To: General Purposes Committee

Date: February 26, 2013

Re: **Non-Farm Use Fill Application by Sunshine Cranberry Farm Ltd No. BC735293
for Property Located at 12871 Steveston Highway.**

Staff Report

Figure B
 Road Location, Fill Placement
 & Planting Plan

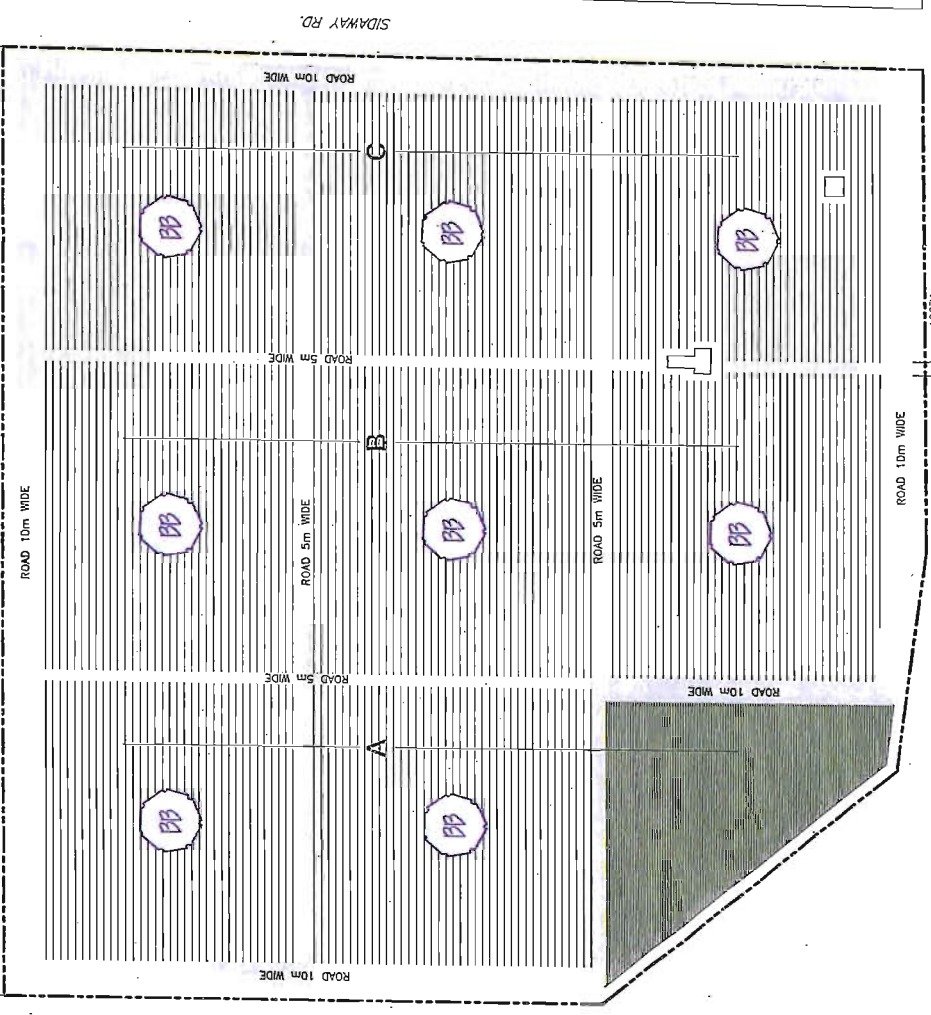
- **Please provide a farm plan which should include a planting scheme showing how the entire portion of the property will be brought into agricultural production.**

- **Please provide a detailed route map and traffic management plan which details the number of anticipated trips per day and access point(s), shortest distance from the nearest arterial road to and from the destination (staff recommend the avoidance of Sidaway Road and the use of No 6 Road as it provides less of an impact to traffic).**

Please refer to Figure B. The fill placement will start with the preparation of road ways around the perimeter of the Site as shown. Fill will begin in area A which is furthest to the west on the Site. As each section is filled, then drainage and topsoil placement will occur. The idea is to bring the property into production in stages depending on the availability of the fill.

Please refer to Figure B. There are two access points to the property. The established access point off of Steveston Highway which is shown on the figure and a second access point which has just recently been developed off of Sidaway Road. The machinery will be accessing the property from these points. Access roads are shown on Figure B

DRAIN SPACING 40'
SLOPE FROM CENTER EAST-WEST

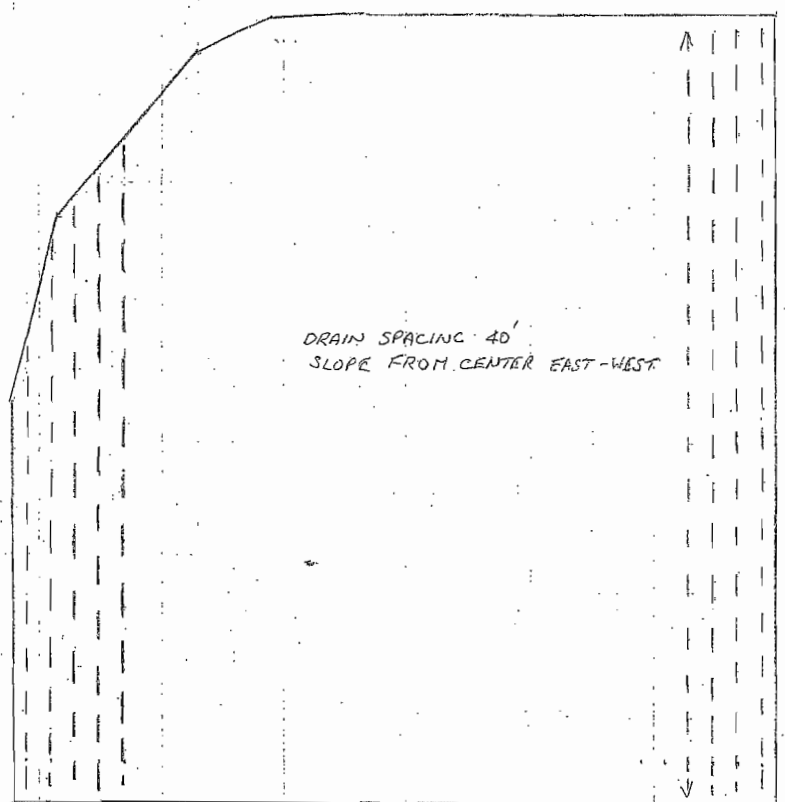
- **A comprehensive drainage and irrigation plan is required. The plan must include layouts, water table and ditch elevations, and any proposed additional ditches that may be required.**

A copy of the revised drainage plan is attached and replaces the drainage plan originally submitted to the City of Richmond in our June 18, 2012 letter referenced: "Requested Information Pertaining to the Sunshine Cranberry Farm ALC Fill Application - 12871 Steveston Highway, Richmond, BC"

To install effective drainage, fill is required and the revised drainage plan requires that a total of 0.88m of fill be placed to raise the grade of the Site. This is a change from the previous drainage plan that required a full 1.0m of fill to be placed. The two other changes are: (i) an increase in the density of the proposed drainage density from the original spacing of 18.2m (60 feet) down to 12.2 m (40 feet); and (ii) a change from a single direction flow design from west to east to one where the drainage moves to both the east and west from a topographic high that is created by the fill placement running north to south on the centre of the Site. The change in design appears to have a three-fold objective. First it will make for a more overall level placement of fill over the Site using less fill. Second it distributes

The change in the proposed amount of fill and drainage plan is acceptable for the planned use of blueberry farming and for general agricultural crop production and is necessary to make the land usable for those purposes. The revised drainage plan is acceptable and does not change any of the conclusions of the originally submitted agrology report for the Site.
